Addendum 1
TFM-082-23A M-166-22 Faculty of Medicine Audio Visual Upgrades

Copy: Andrew Kozak, EH **Project:** EH# 22405,
Memorial University of Newfoundland
Faculty of Medicine AV Systems

From: Romeo Labio **RE:** *TFM-082-23(A) Request for Open
Call - Addendum AV-01*

PROJECT NO.	Z095
DRAWN BY	Author
DATE	2023-09-08
SHEET NO.	AV-600 R1

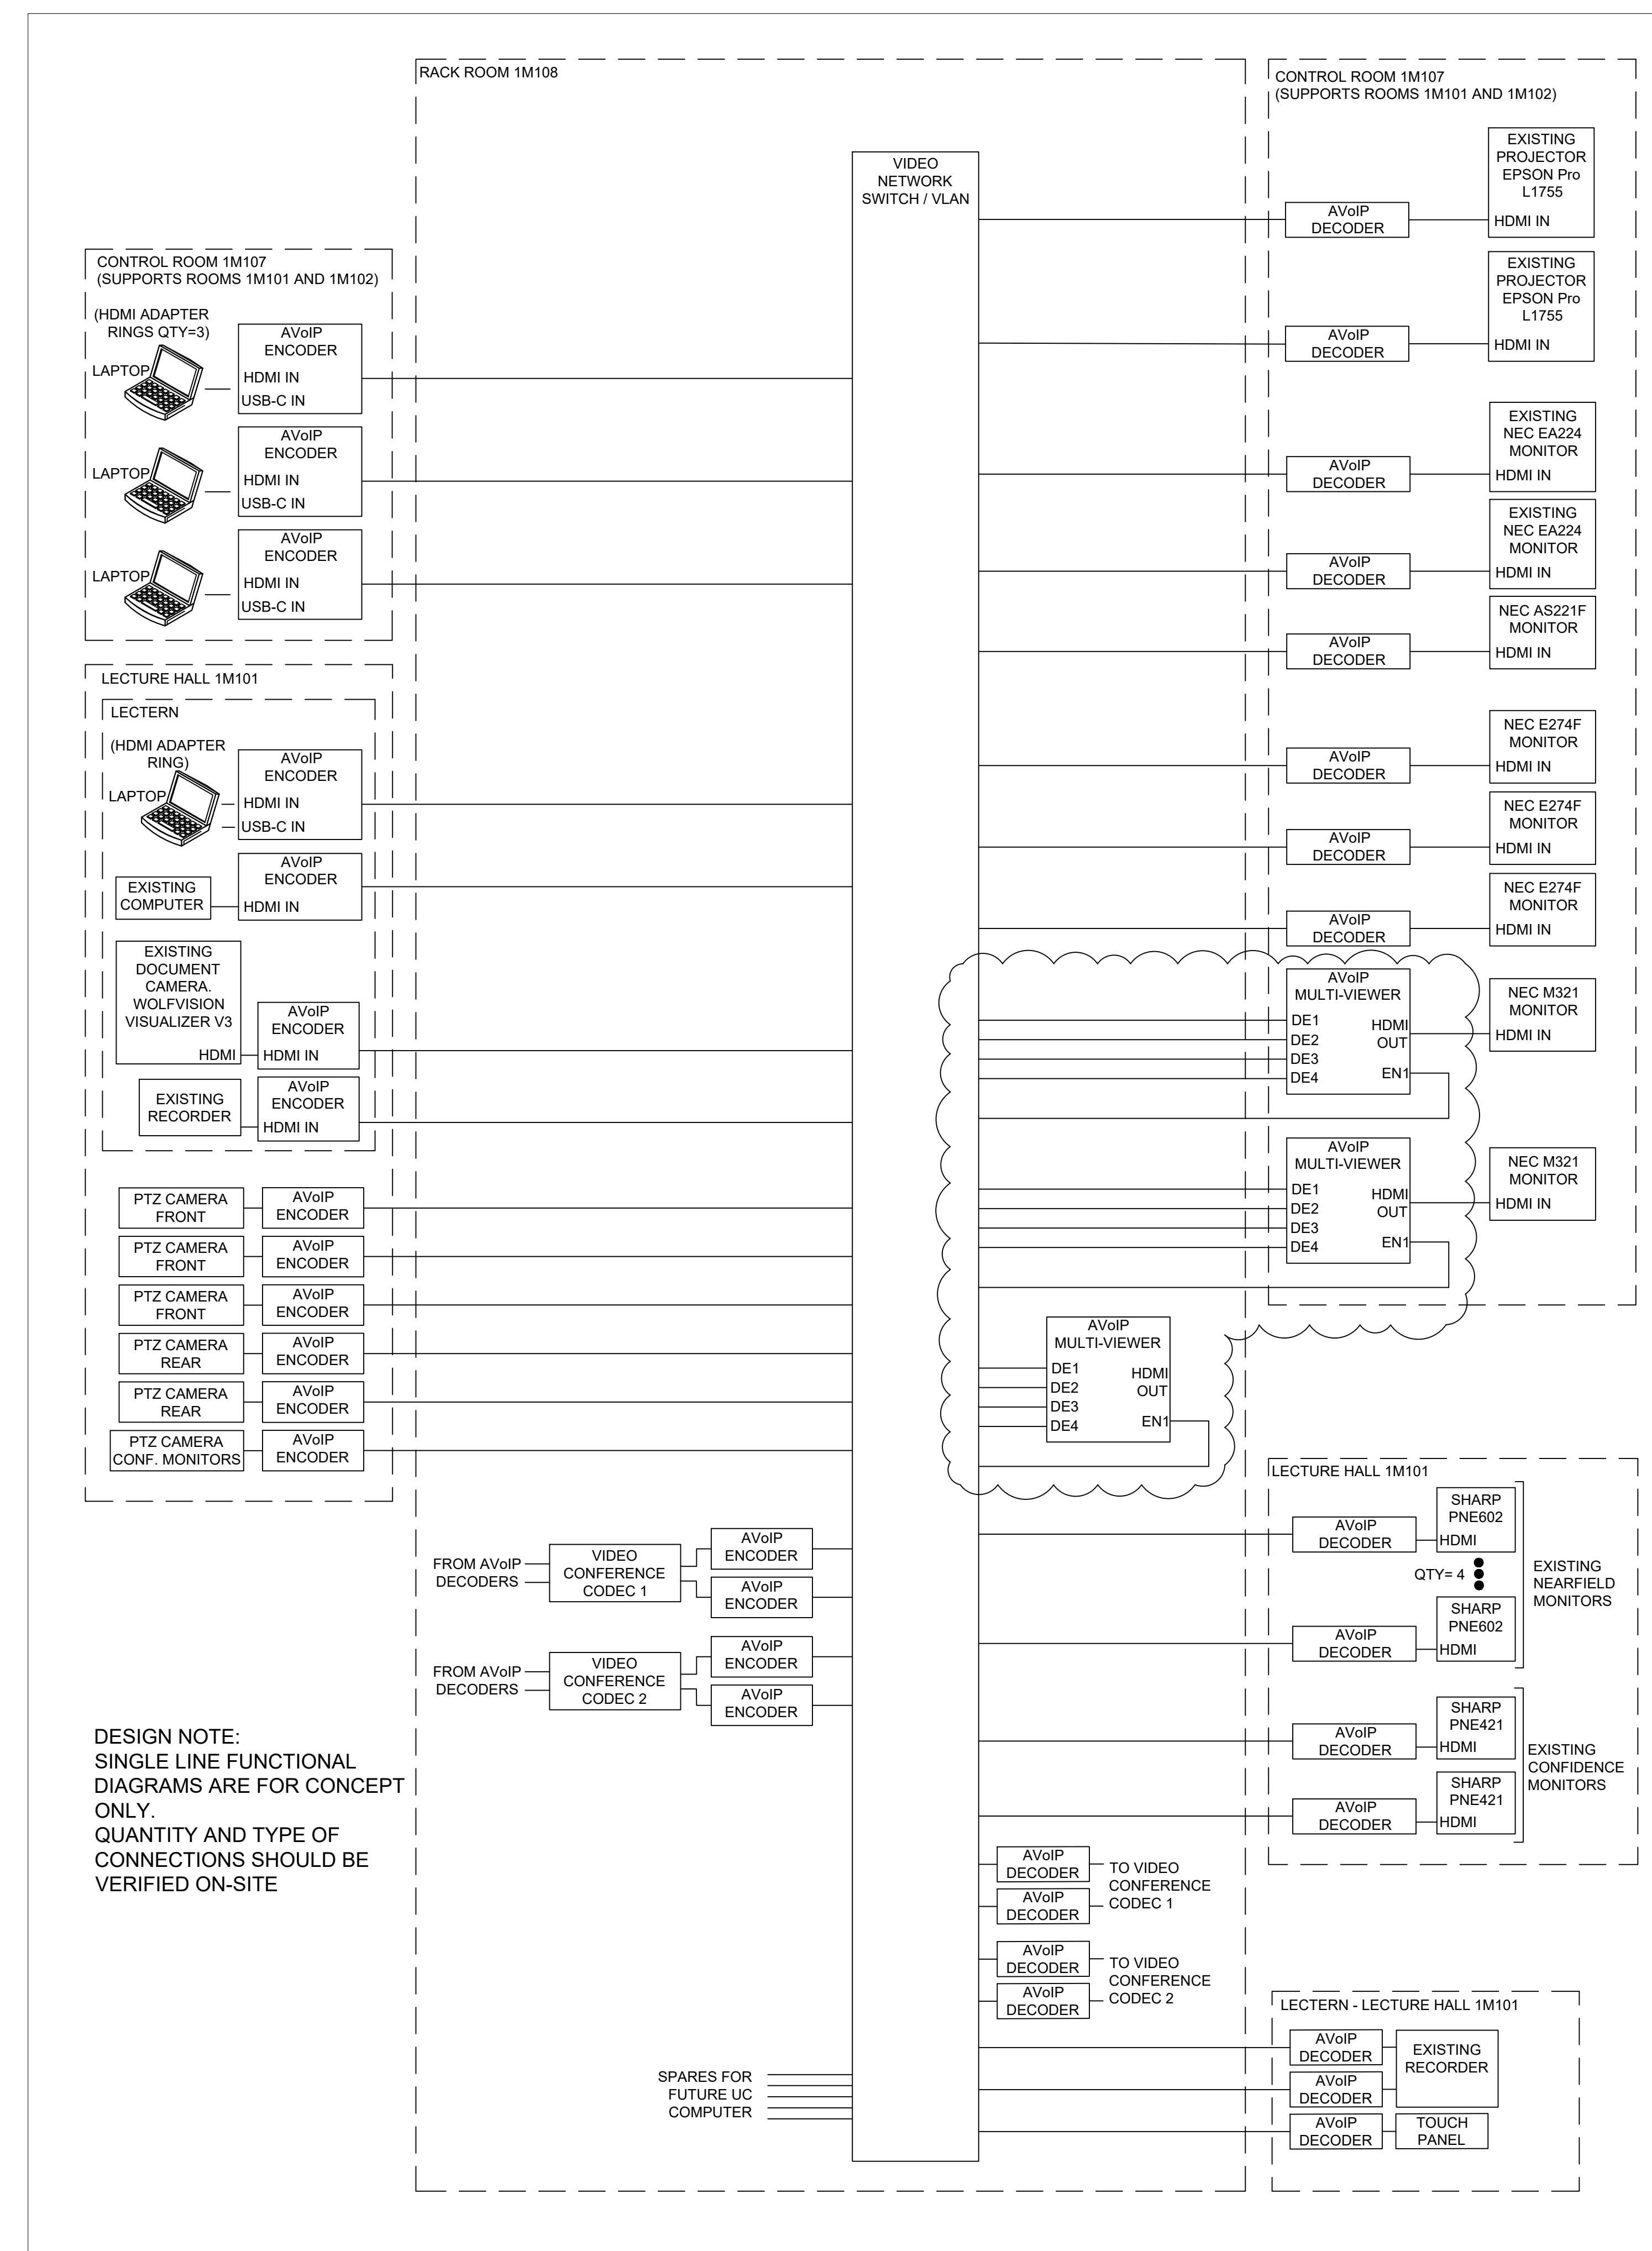
1. Section 2.6.3 Module A: Tiered Lecture Hall with Control Room – Equipment
 - a. Provide (2) AVoIP multiviewer to be located at the control desk area in room 1M107. Connect the HDMI out of the multiviewers to the desk preview monitors of the operators.
 - b. Provide (1) AVoIP multiviewer to be mounted in the equipment rack in room 1M108. This multiviewer shall be used for showing windowed content on the screens during video conferencing call.
 - c. See attached functional drawing;
 - i. AV-600 to be deleted.
 - ii. AV-600 R1 to be added.
 - d. The Amend equipment list to be added to the existing table:

PROJECT NO: 2205
DRAWN BY: Author
DATE: 2023-09-08
SHEET NO: AV-602 R1

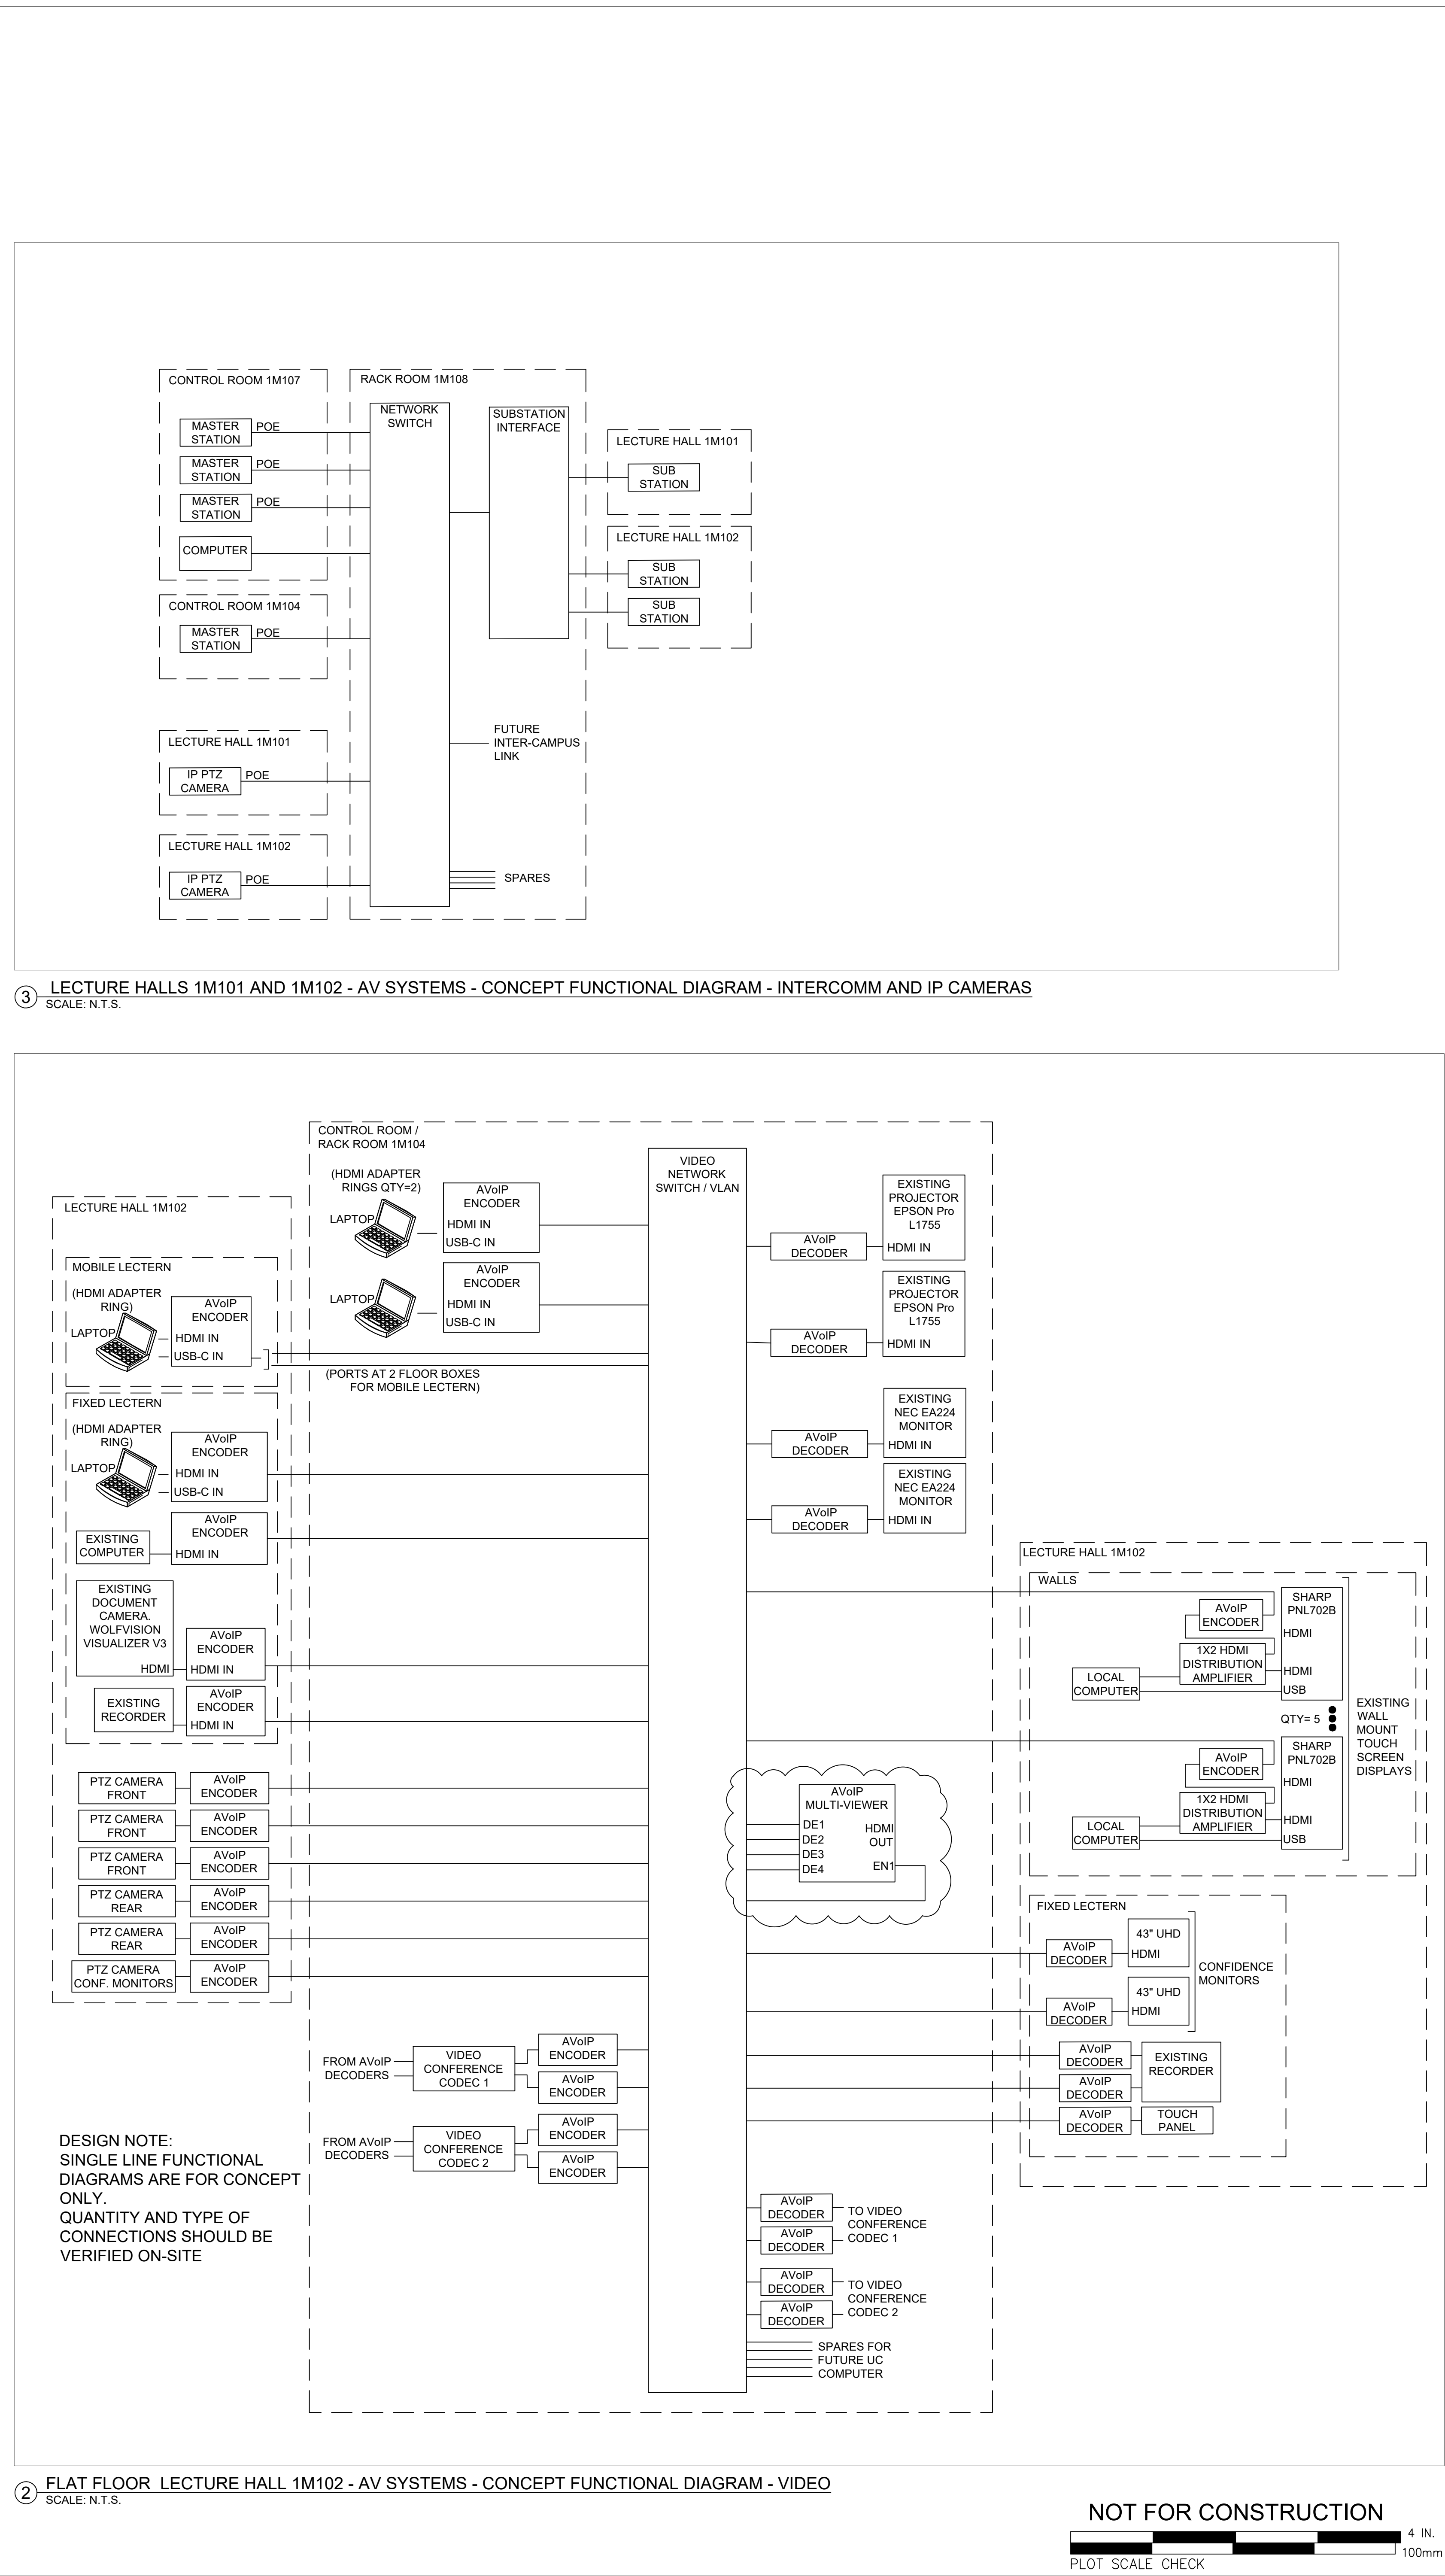
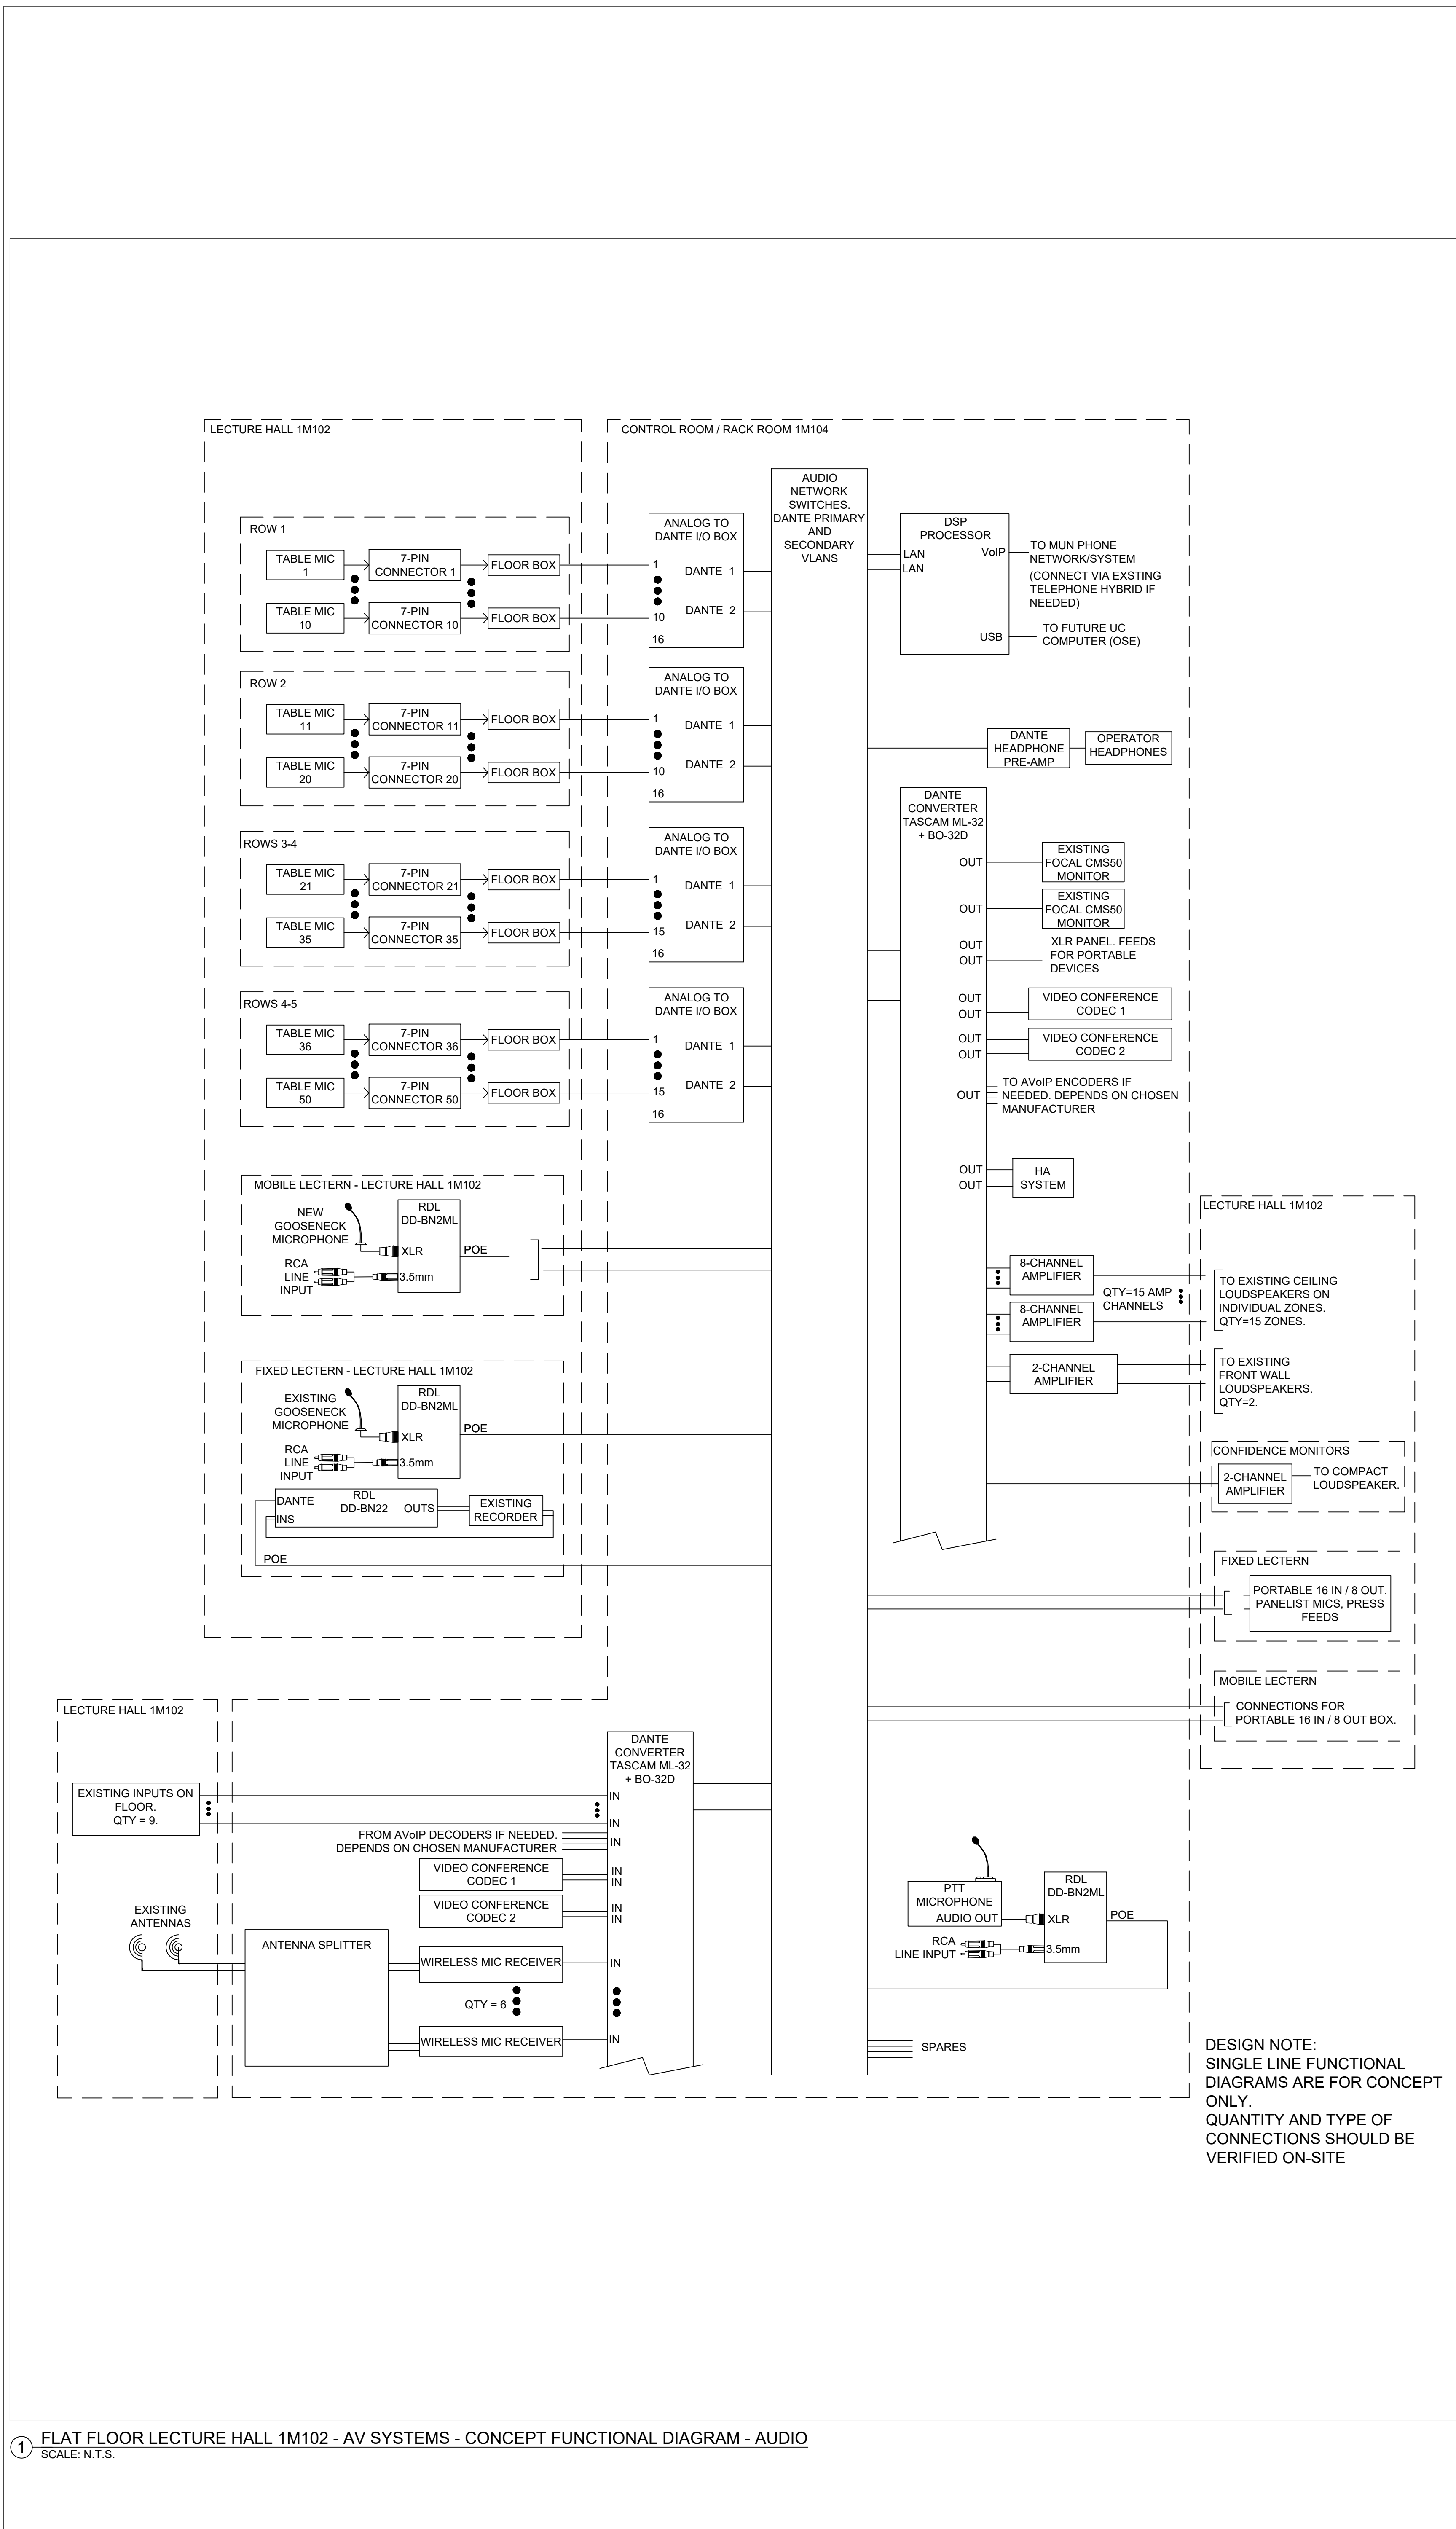
2. Section 2.13.3 Module B: Flat Floor Interactive Learning Room – Equipment
 - a. Provide (1) AVoIP multiviewer to be mounted in the equipment rack in room 1M104. This multiviewer shall be used for showing windowed content on the screen during video conferencing call.

- b. See attached functional drawing;
 - i. AV-602 to be deleted.
 - ii. AV-602 R1 to be added.
- c. The Amend equipment list to be added to the existing table:
